GROVE & DALL'OLIO
ARCHITECTS PLLC

Addendum #4

| Re: Claggett Center Barn | |

The following information clarifies the information in the drawings dated 10/1/2021:

A3.2

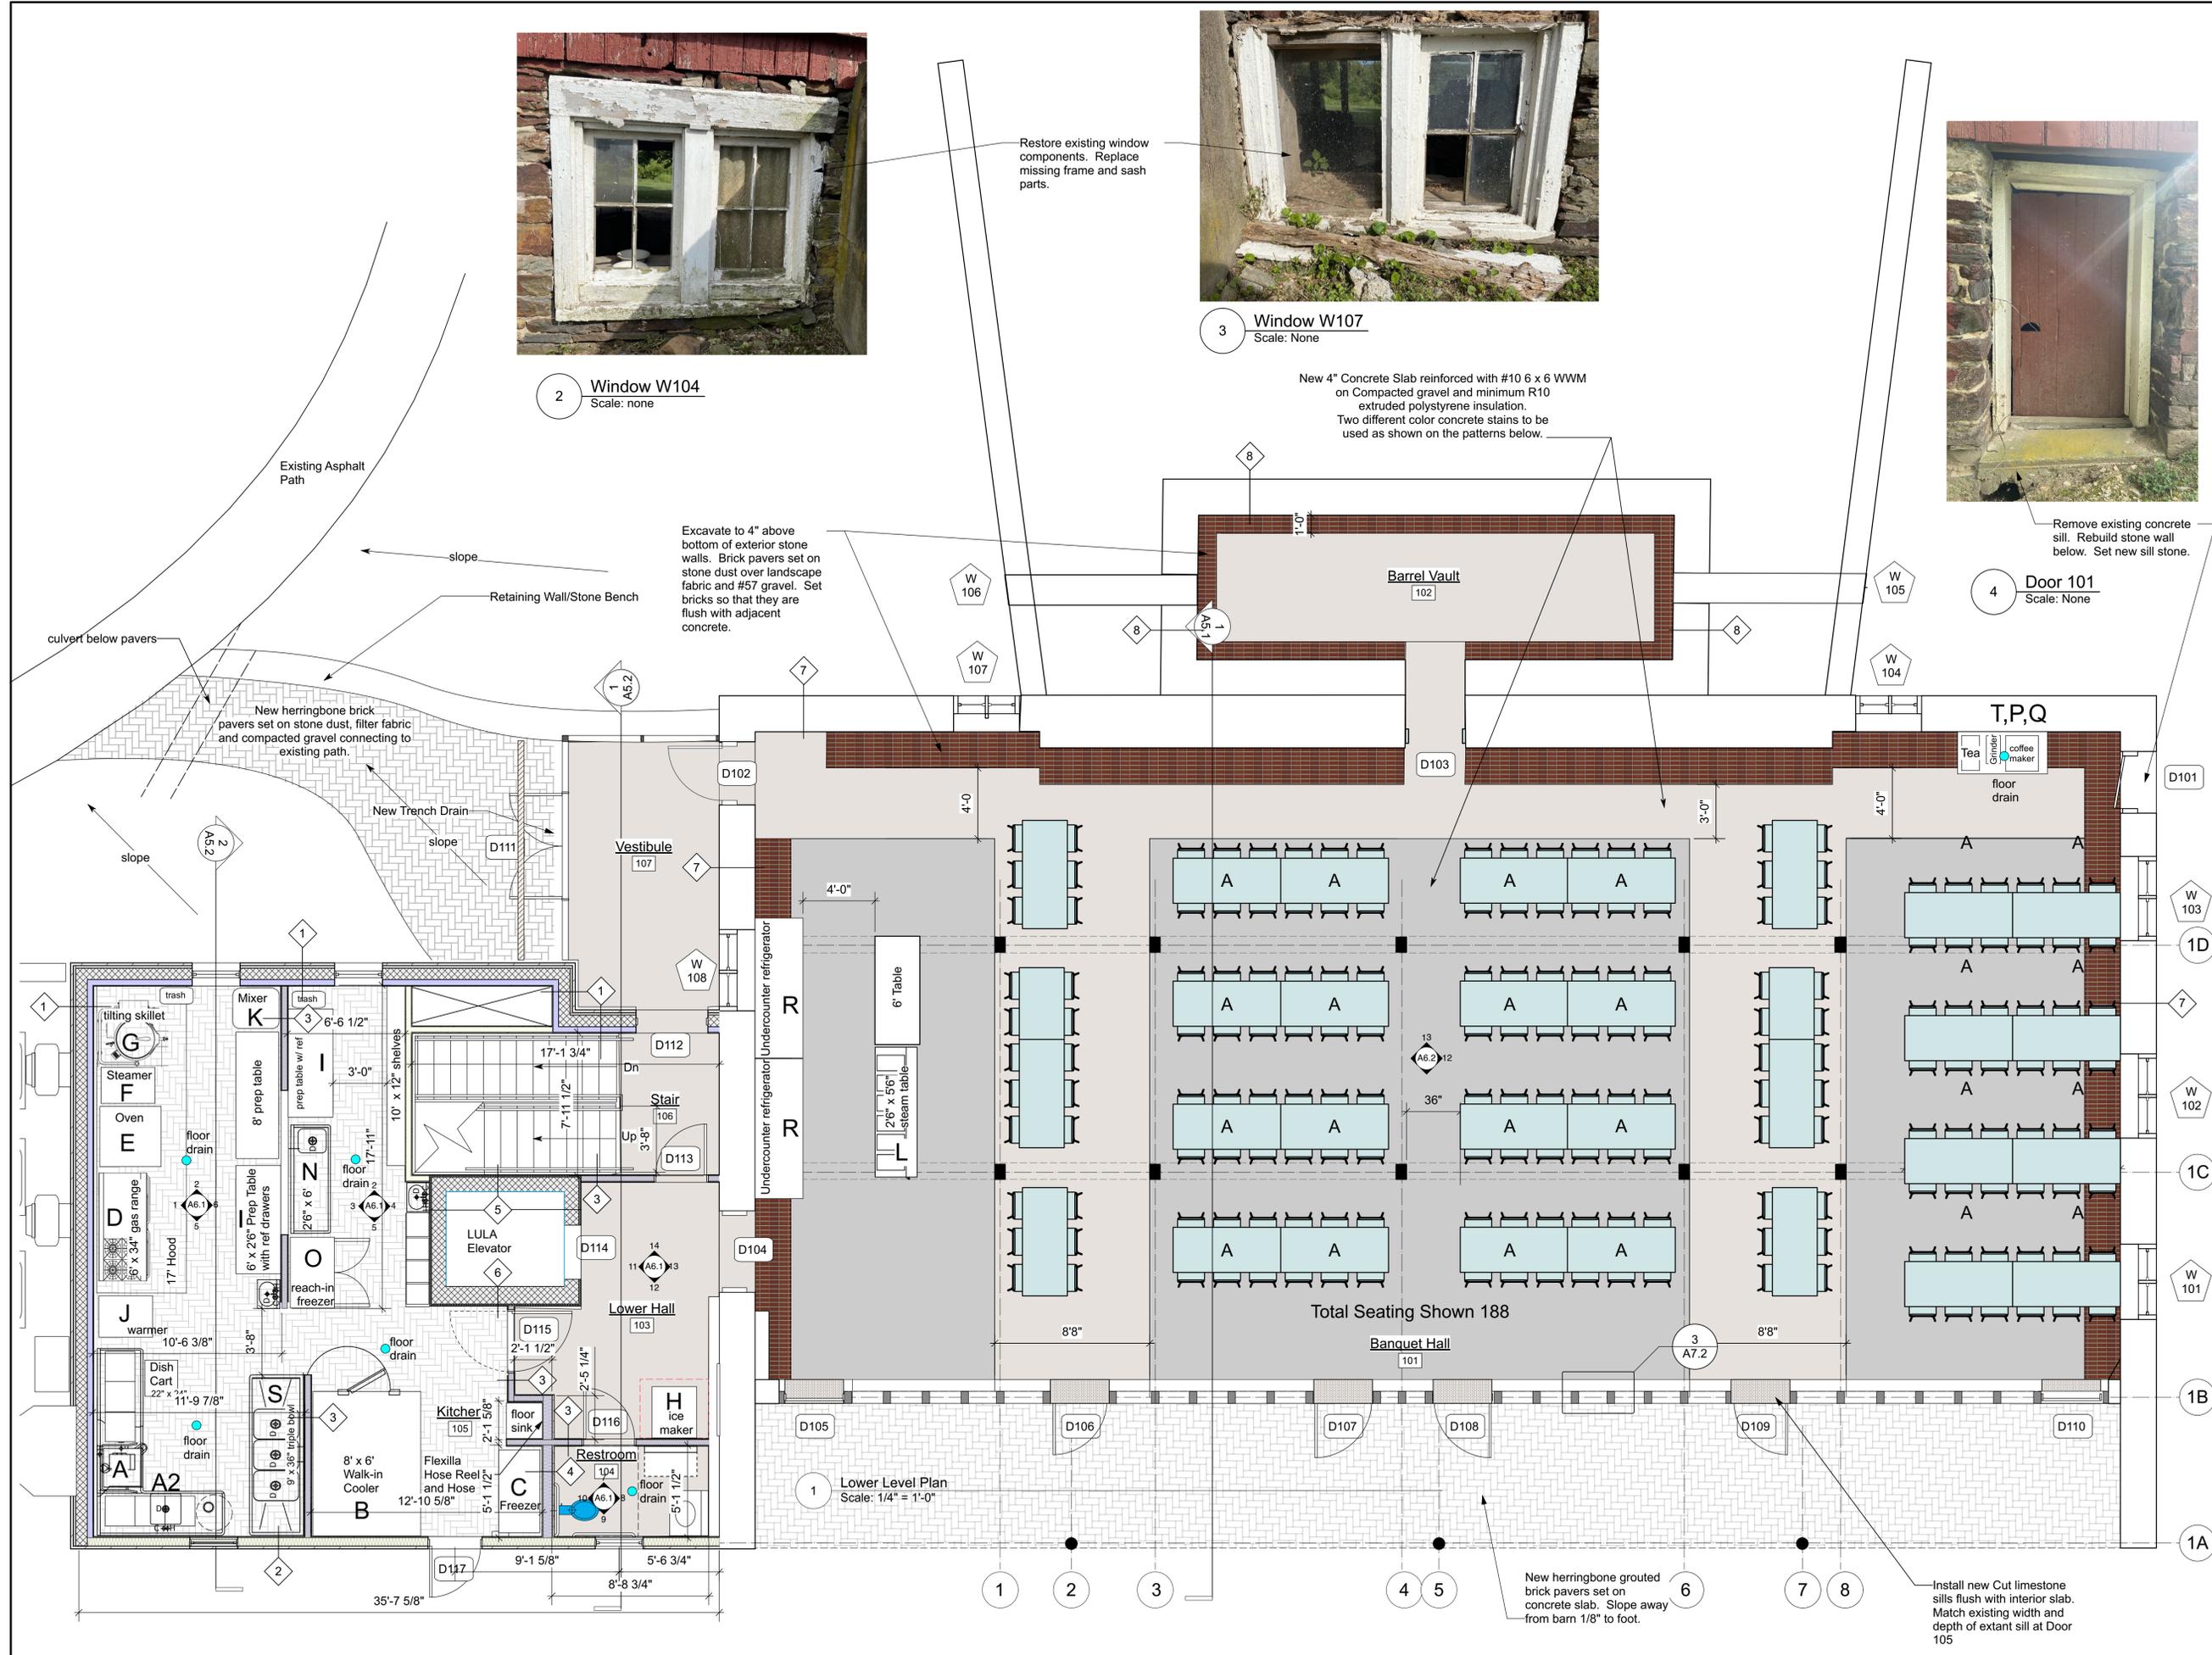
4. Question: Please provide Floor Plan with dimensions, (3) Exterior Elevations and a Wall Section through the Condenser Farm.

Answer: Upper and Lower Floor Plans with additional dimensions are herewith provided. Additional dimensions of the condenser farm will be provided tomorrow as a final addendum #5.
